CONDITIONS OF APPROVAL

SDR2009-00007

AUTOZONE STORE

PRELIMINARY SITE DEVELOPMENT PLAN FOR:
AUTOZONE STORE NO. 3756
 A SITE IN THE CITY OF TIGARD, OREGON

DESIGNER:
 DATE:
 SCALE:
 SHEET:
 SP1.0

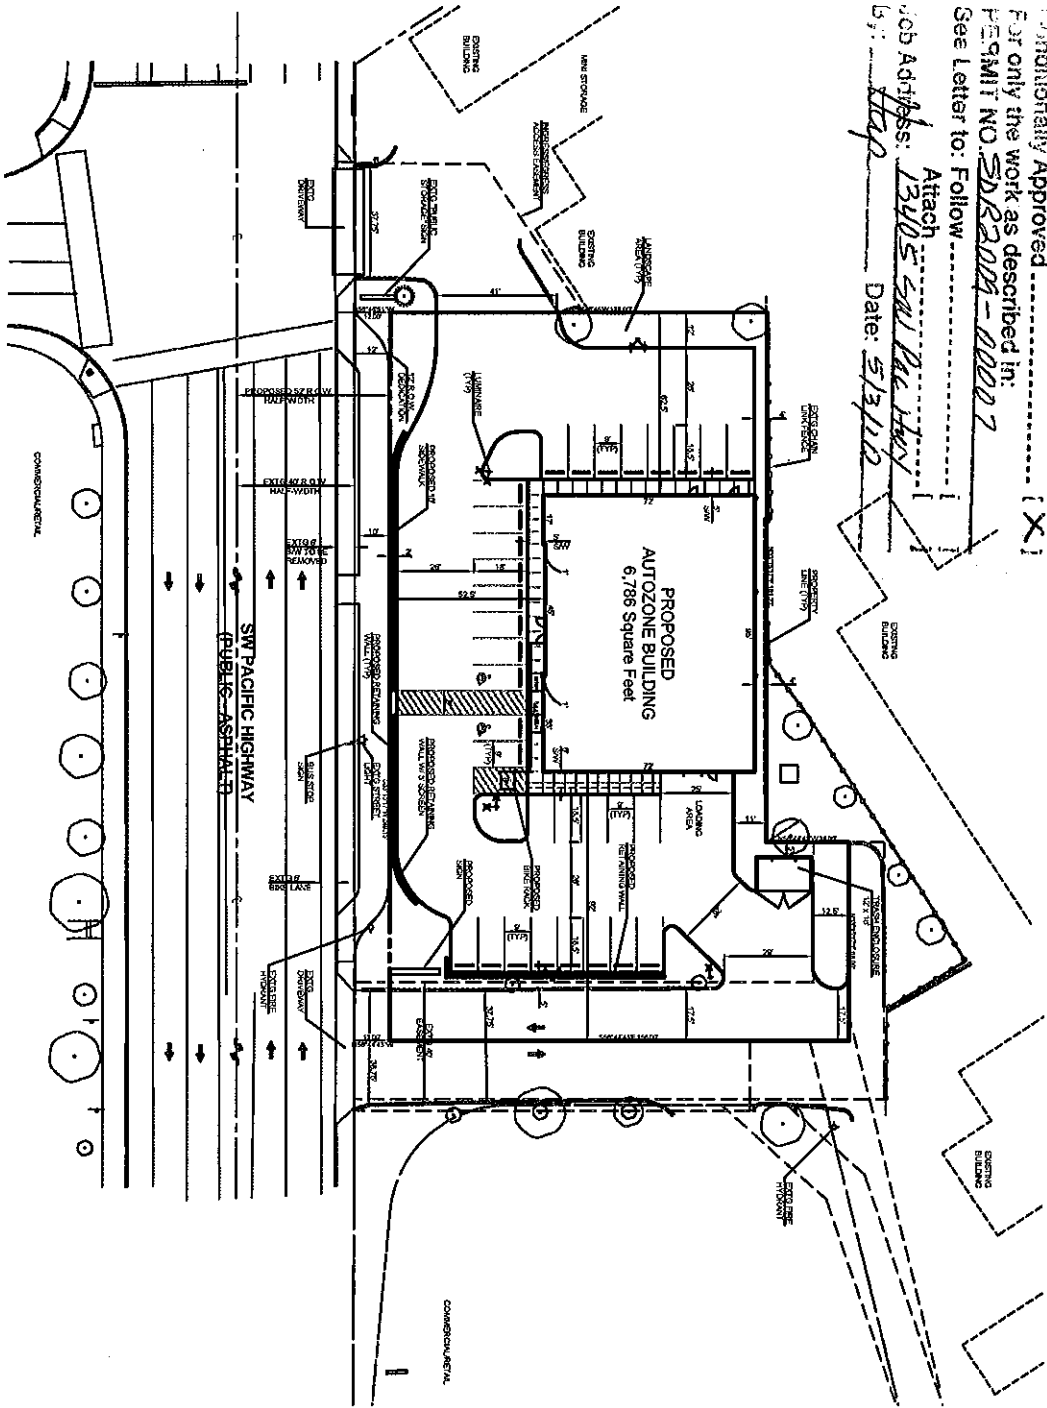
2. The applicant shall provide revised plans that show the storm water control vault shown on Sheet C3.0 re-located onto private property from its current location in the planter strip, show the new parking lot storm drain lines re-located to the revised water control vault location, and show the direction of flow for the water detention system.

Plan sheet C3.0 shall indicate direction of flow for the water detention system.

The storm water control vault shown on Sheet C3.0 must be re-located onto private property from its current location in the planter strip.

The new parking lot storm drain lines must be re-located to the revised water control vault location.
